Comparison of Old and New D5 Indicator

Introduction

Overall Comparison

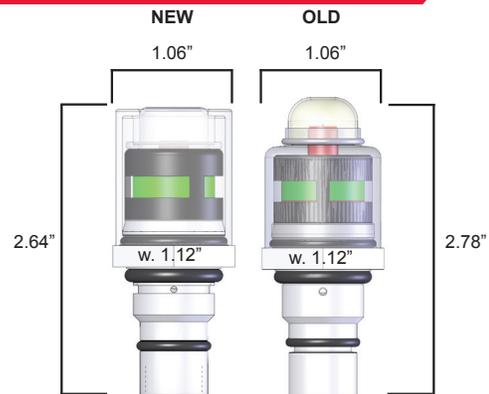
Improved function and durability
Silicone reset button now protected
Works in same indicator ports
Hex area remained the same for easy replacement
Lower profile
Same Viton® o-ring and stainless steel body options
The new, heavy duty D5 has a rigid polycarbonate sleeve that protects the recessed silicone cap from side contact.

Internal Comparison

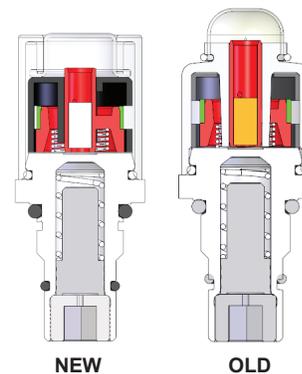
Same range of spring settings
Simplified design yields a compact upper half
Improved component tolerances ensure superior performance
Another improvement made in the design of the new, heavy duty D5 is the reset button cover. The thickness of the cover has been increased by 45%. Tearing of the reset button area is no longer an issue with the more robust design.
